Subject Amendment No. 2, Purchase Order Contract - RMT Landscape Contractors, Inc.-
 Claremont Landscaping Project

**AMENDMENT NO. 2 TO INDEPENDENT
CONSULTANT CONTRACT**

Architectural Supplementary Instruction: ASI # 31.1 r.1
dated 4/24/13

TITLE: Clarification of finishes, tackboards

DSA# 01-111714
 SCALE: 1/4"=1'-0"
 date 4/22/13
 ASI #31.1
 SK-A114

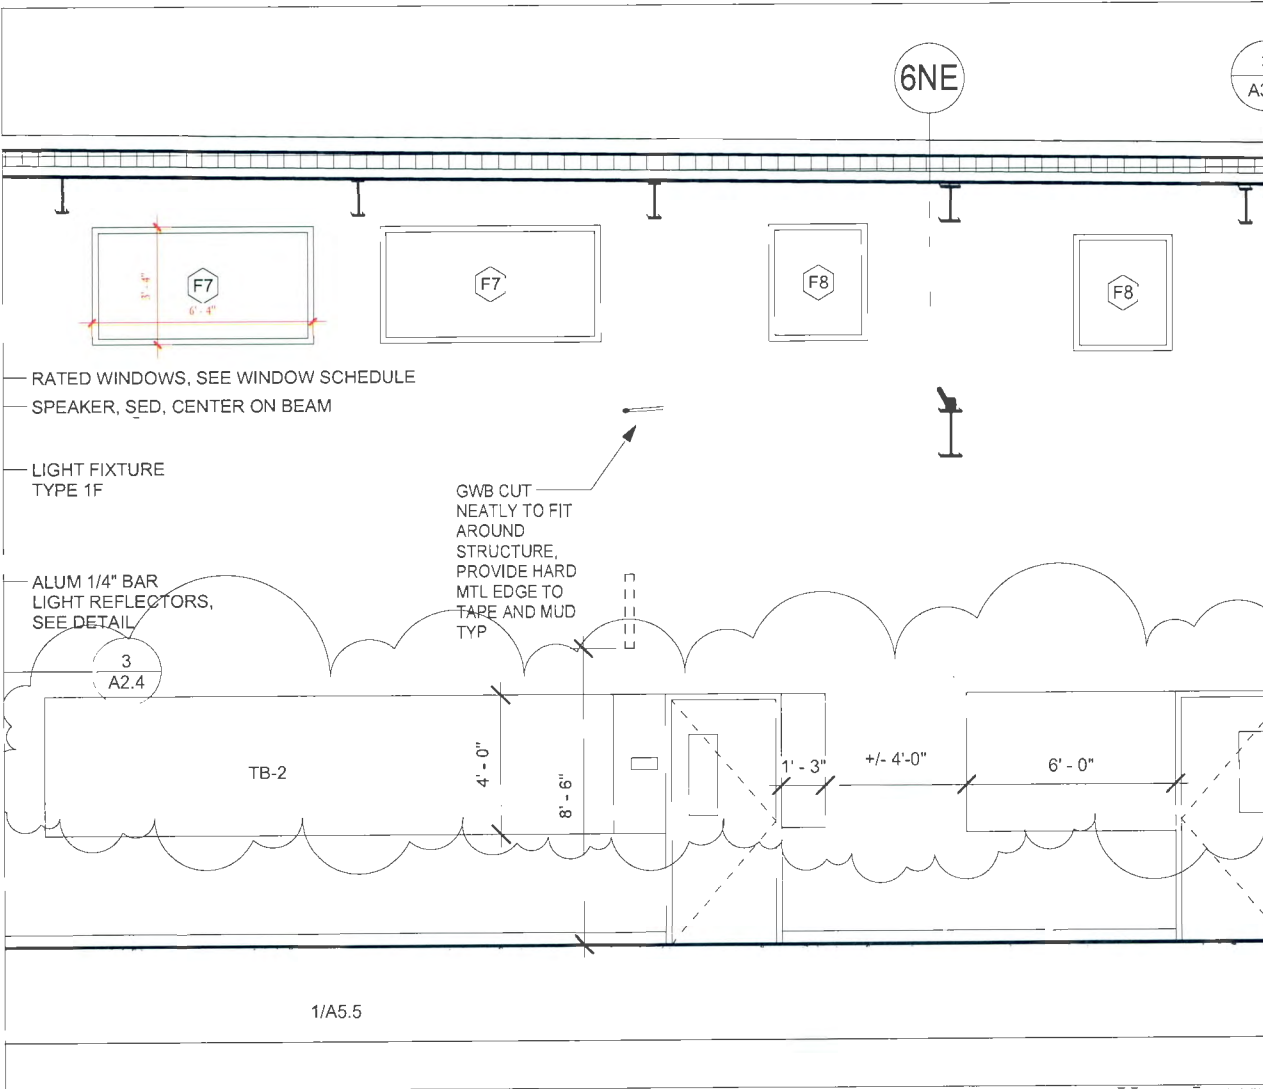
b) At the corridor, the TB-2 shall be 4' tall on both North and South side. See SK-A114. Provide credit to owner for material (originally TB was almost 8' tall)

and SK-A114.1

DSA# 01-111714
 SCALE: 1/4" = 1'-0"
 ASI 31.1 4/22/13
 SK-A112

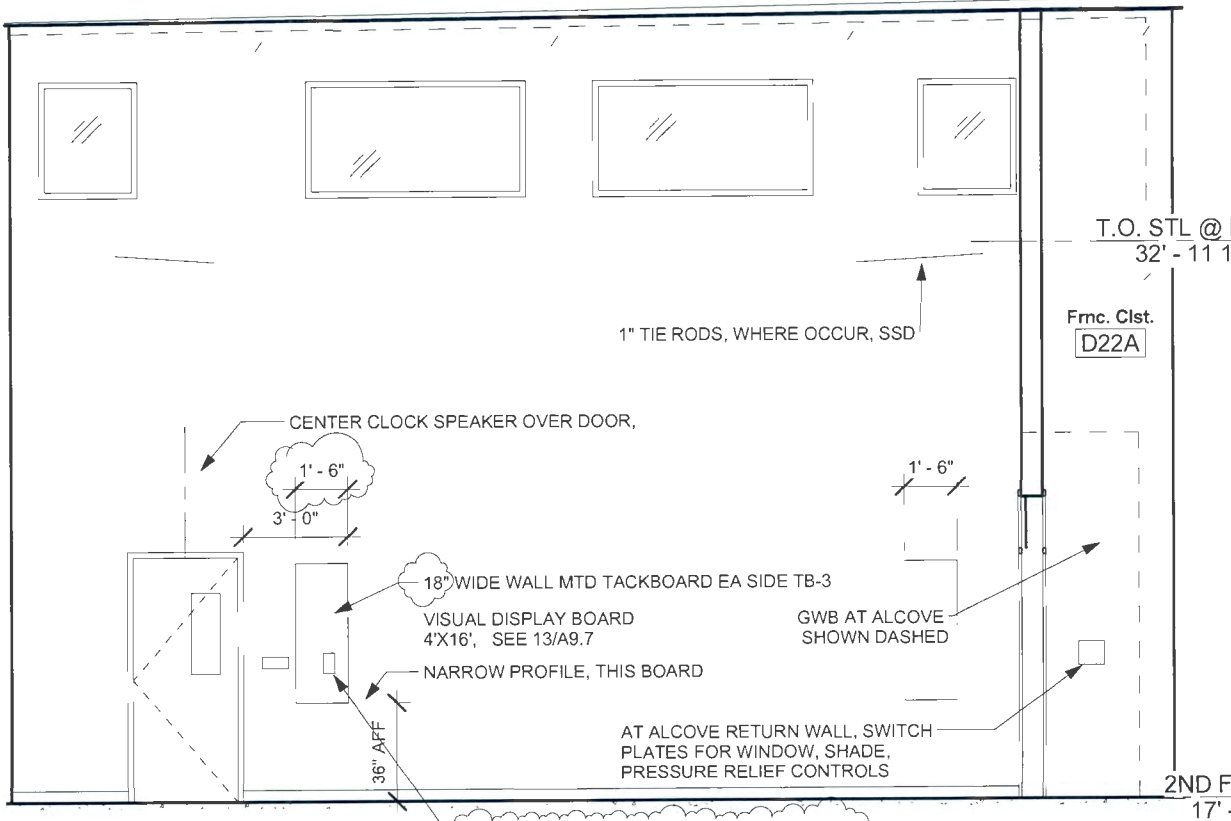
a) at the wall against the corridor (north elevation in classrooms D24, D25, D26)(south elevation in classrooms D21, D22, D23), the tackboard TB-3 shall be 18" wide on each side – See SK-A112
